**MAJOR MODIFICATION**  
**TO THE**  
**OPERABLE UNIT 1: 881 HILLSIDE AREA**  
**CORRECTIVE ACTION DECISION/RECORD**  
**OF DECISION**

**Rocky Flats Environmental Technology Site**  
**Golden, Colorado**

**January 2001**

Figure 3. OU 1 Collection Well Trichloroethene Concentrations and Projection.

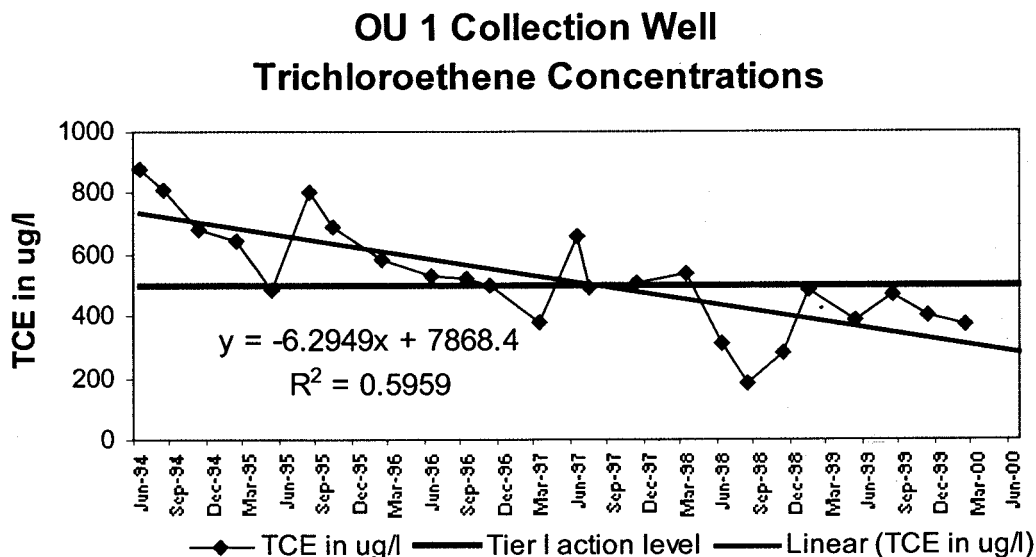
Comment: The declining trend identified in Figure 1 is not reflective of statistical means, nor does the figure correlate concentrations to dry seasons or wet seasons. Figure 1 reflects a linear regression, not a statistical regression; therefore, Tier I levels may be exceeded in the future. Broomfield agrees with the EPA's recommendations to continue collection of the groundwater to reduce the concentration of TCE to a level approximating the Tier II groundwater value. The City of Broomfield recommends collection and treatment of groundwater to continue until Tier II values are achieved for a continuous two-year period to ensure concentrations of TCE are stable and below Tier I levels during wet seasons. Continuing the treatment and removal of TCE ensures there will be protection of surface water standards. DOE assumed natural attenuation will occur, therefore reducing the impact to surface water. DOE also assumes the linear regression model accurately represents the system, but seasonal precipitation is a variable that is not factored into the linear regression model. What modeling was used to confirm surface water would not be impacted at levels two orders of magnitude or less? Broomfield would appreciate the opportunity to review the modeling performed.

Comment: The simple linear regression of TCE concentrations over time as noted in Figure 1 (OU1 Collection Well Trichloroethene Concentrations Projections) shows the r-squared value of 0.5959. A value that was closer to 1 would provide greater confidence that a declining trend was indeed occurring. Rather than relying on an assumption that natural attenuation is taking place, and that the linear regression model accurately reflects the system, DOE is strongly encouraged to maintain the system for three more years in order to obtain better statistical data to prove that the trend is actually occurring.

Response: We appreciate Broomfield's visit to the Site on August 11<sup>th</sup>. The following responses summarize the data provided and also provide additional clarification. Water quality and volume data for the Collection Well and French Drain were provided to Broomfield on August 15<sup>th</sup>.

There are declining concentrations at both the Collection Well and the downgradient well. As noted, there are seasonal variations in the TCE concentrations at the Collection Well. However, even with these variations, contaminant concentrations are consistently below Tier II action levels in the French Drain. This evaluation, now included in the modification, shows that there is no impact to surface water.

Response: The simple regression was based on data available since the Collection Well was installed in 1992 and indicates a general declining trend but also shows seasonal and weather-related variability. A regression based on the average annual concentrations resulted in an r-squared value of 0.82 corroborating the declining trend. In addition, when data from the Collection Well were segregated by quarter, to eliminate seasonality, each quarter's results also show strong declining trends.
